In the Matter of the Application of Enbridge Energy,  
Limited Partnership for a Certificate of Need for the  
Line 3 Replacement Project in Minnesota from the  
North Dakota Border to the Wisconsin Border

In the Matter of the Application of Enbridge Energy,  
Limited Partnership for a Routing Permit for the  
Line 3 Replacement Project in Minnesota From the  
North Dakota Border to the Wisconsin Border

**Fond du Lac Band of Lake Superior Chippewa Comments on Draft  
Environmental Impact Statement**

The Leech Lake Band of Ojibwe Environmental-Land Department has compiled a list of comments that need to be addressed in the Draft Environmental Impact Statement for Enbridge Line 3 Project. Please see comments below:

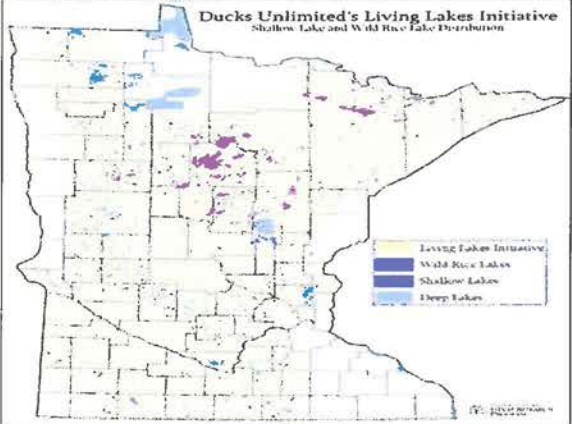
PAGE	CHAPTER	TEXT	COMMENTS
ES-1	Executive Summary	5 <sup>th</sup> Paragraph "as well as ceded territory that tribal members value for wild rice, hunting, and fishing"	The sentence is bias against avoiding the reservations because it reads like the ceded territories are the highest value because of wild rice. When tribal members highest valued wild rice beds are on reservation. That's why we asked for there to be no more new pipelines through the Leech Lake Indian Reservation. So this sentences shouldn't read that value is just ceded territory but should include also on reservation rice beds.
ES-6	Executive Summary	Figure ES-2	The maps coloring needs to be enhanced to better represent the large water resource within the reservations. Figure ES-3 is better representation.
ES-7	Executive Summary	6 <sup>th</sup> Paragraph "through amicable Agreements"	The Leech Lake Band of Ojibwe has publically stated they would not allow any new pipelines and has also memorialized this decision in Leech Lake Statute. Since the title of the section is " <b>How do the tribal and federal approvals affect route decision?</b> " The opening paragraph in the section should lead off with that there is not going to be any amicable ROW given

ES-26	Executive Summary	Figure ES-10	Figure ES-10 Provides a comparison of high quality water resources at risk for each route. The comparison is imbalanced because when you're trying to reflect Wild Rice/Water resource impacts you have to also compare the size water body and size of harvestable wild rice beds. Lake Winniboshish 4 <sup>th</sup> largest lake in Minnesota has more water volume and acres of wild rice beds then all the other individual routes. These Water Resources comparison can not reflect just number of lakes but an actual comparison would reflect acres of water resources crossed. Having a 200 acre lake have the same value as a 56,000 acre lake is not a good comparison.   <p>A version of this map is located on Pg. 6-198 but it is missing several large wild rice bodies.</p>	2369-13

6-189	Chapter 6	Methodology	Leech Lake Division of Resource Management Data set wasn't used to identify wild rice bodies.	2369-16
6-190	Chapter 6	Overview of Wild Rice Water Bodies "Wild Rice waterbodies are shallow bodies of water where rice, a persistent annual grass"	Line is incorrect Wild Rice water bodies come in all ranges of depths on Leech Lake Indian Reservation. Some wild rice beds have a depth of up to 10 feet.	2369-17
6-198	Chapter 6	Figure 6.3.1.2-1. Is incomplete.	Mud Lake, Pike Bay, Sucker Lakes Chain, Portage, Boy River, Leech River and Steamboat lake are all missing from map.	2369-18
